APPLICATION BY NNB GENERATION COMPANY (SZC) LIMITED FOR AN ORDER GRANTING
DEVELOPMENT CONSENT FOR THE SIZEWELL C PROJECT

AMENDMENT TO THE APPLICATION AND INCLUSION OF ADDITIONAL LAND

Submission to Planning Inspectorate on behalf of Suffolk Building Preservation Trust concerning the impact of proposals regarding Pakenham Fen and the operation of the historic Pakenham Water Mill

Figure 1 Drainage System & Source of Water

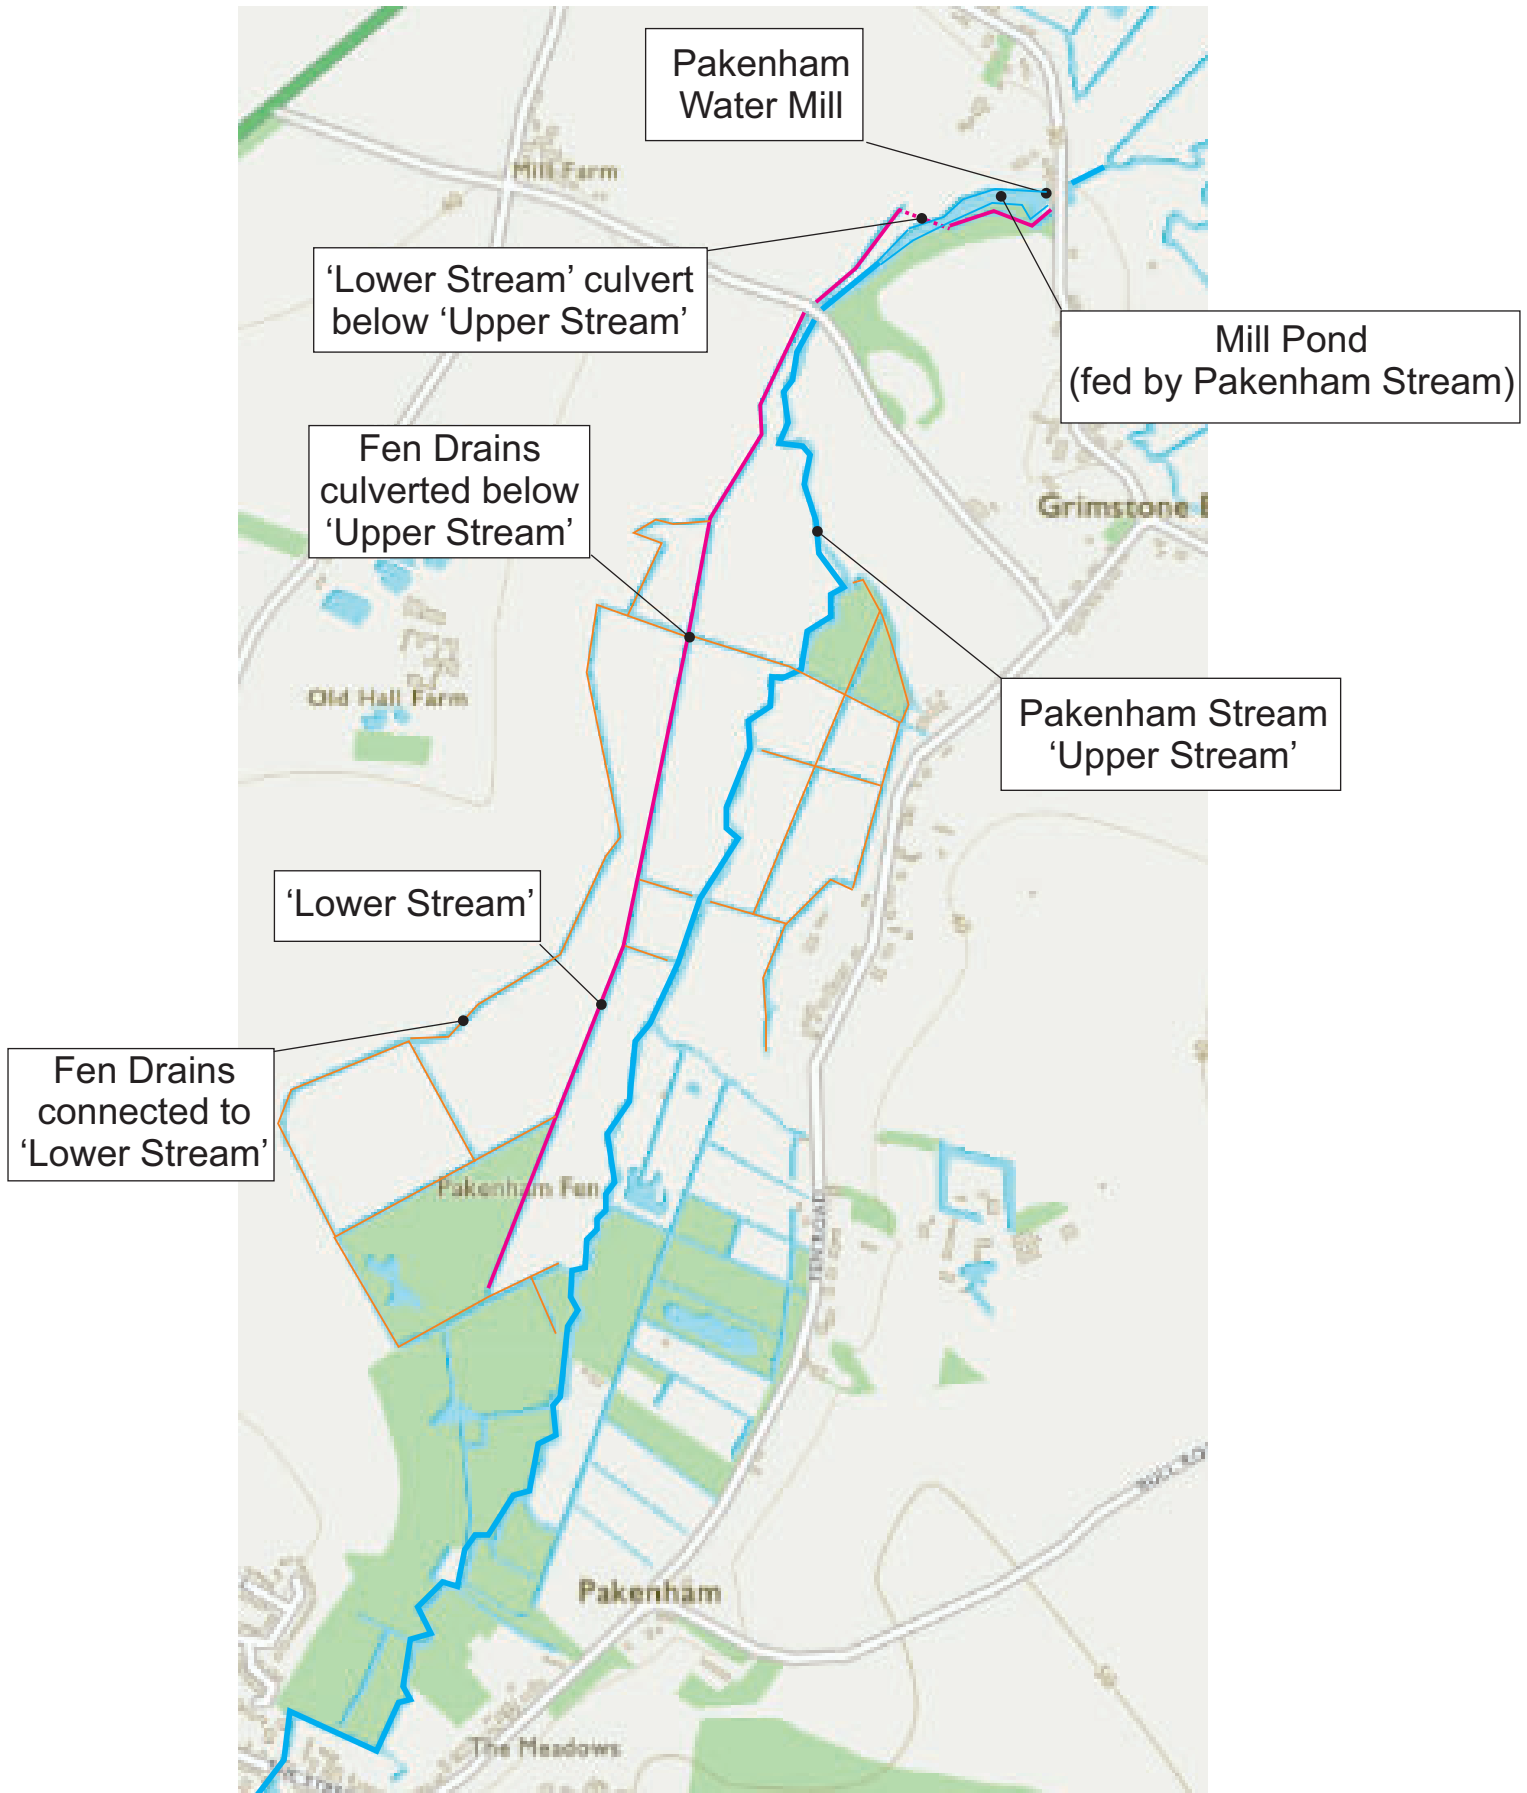
5. The mill pond is fed by the Pakenham Stream (Figure 1), the catchment for which extends over c. 37km² (3747ha).
6. The flow in the stream is maintained by rainfall runoff, as well as groundwater from the shallow and deeper geology. The groundwater flow is critical in sustaining flows through the late spring, summer and early autumn.

7. An important feature of the drainage of the Pakenham Stream and the way in which it feeds the mill pond. In its present and historical configuration, Pakenham Stream does not feed into the fen; that is, the flow in the stream is carried through Pakenham Fen and is not connected to the Fen. Locally the Pakenham Stream is known as the "upper stream", as opposed to the "lower stream" which is discussed below.

9. A series of ditches drain Pakenham Fen, the land to the east of Pakenham Stream being drained by ditches and culverts **under** the Pakenham Stream. This water leaves the Fen area by the “lower stream” which runs north, parallel to Pakenham Stream and passes in a culvert **underneath** the mill pond (Figure 1). The two streams merge after the mill pond sluice on their way to Mickle Mere where they join the Blackborne River. There should be no connection between the upper and lower streams. Only through poor maintenance of the riverbanks by riparian owners will water be lost from Pakenham Stream to the “lower stream”.

Figure 2 Proposed Area of Protected Fen Meadow

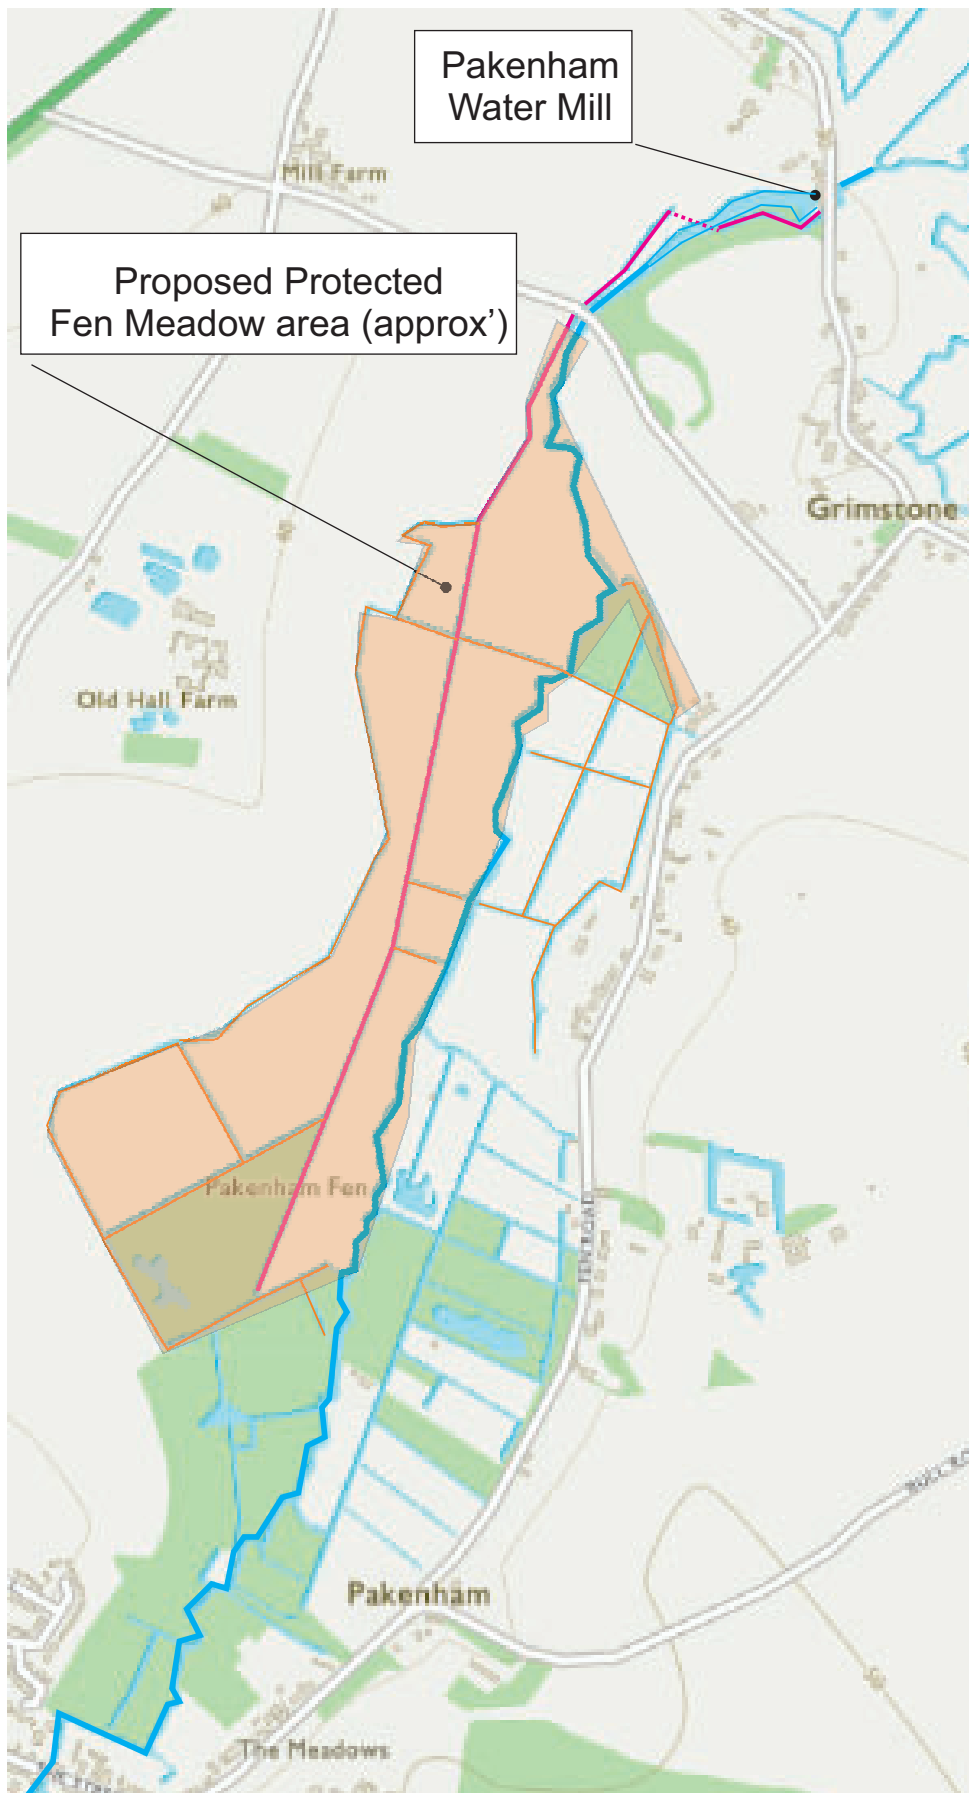
11. The proposed area for the fen meadow development is shown running along the boundary of Pakenham Stream (Figure 2), which feeds the mill pond. Any alteration to the adjoining land could have an impact on the supply of water to the Mill.

12. For the fen meadow to function it will require a supply of water, over and above what is on the land today. If this were not the case, then the land would already be a fen meadow. The land in question is in an intimate upstream relationship with the Mill and it is reasonable to assume that the land drainage that has evolved over millennia has taken the Mills requirements into account. Indeed, historically, it is likely that it was in the interests of all land managers to ensure that the Mill could function. The reference in the Enclosure Act demonstrates this position. This historic perspective, well known to the Trust, has not been investigated by EDF.

13. An increase in the supply of water to Pakenham Fen can be achieved in two fundamental ways, either by diverting water from Pakenham Stream, or by lowering the ground level in order to access shallow groundwater.

14. Diverting water from Pakenham Stream will have a direct impact and increasing access to groundwater will have an indirect impact, on the water supply to the Mill. Increasing losses from groundwater, either by increased uptake by the plants, or by diverting it to the "lower stream" has a high probability of reducing late spring, summer and early autumn flow in the "upper Stream" (Pakenham Stream). The magnitude of this impact has not been assessed by EDF.
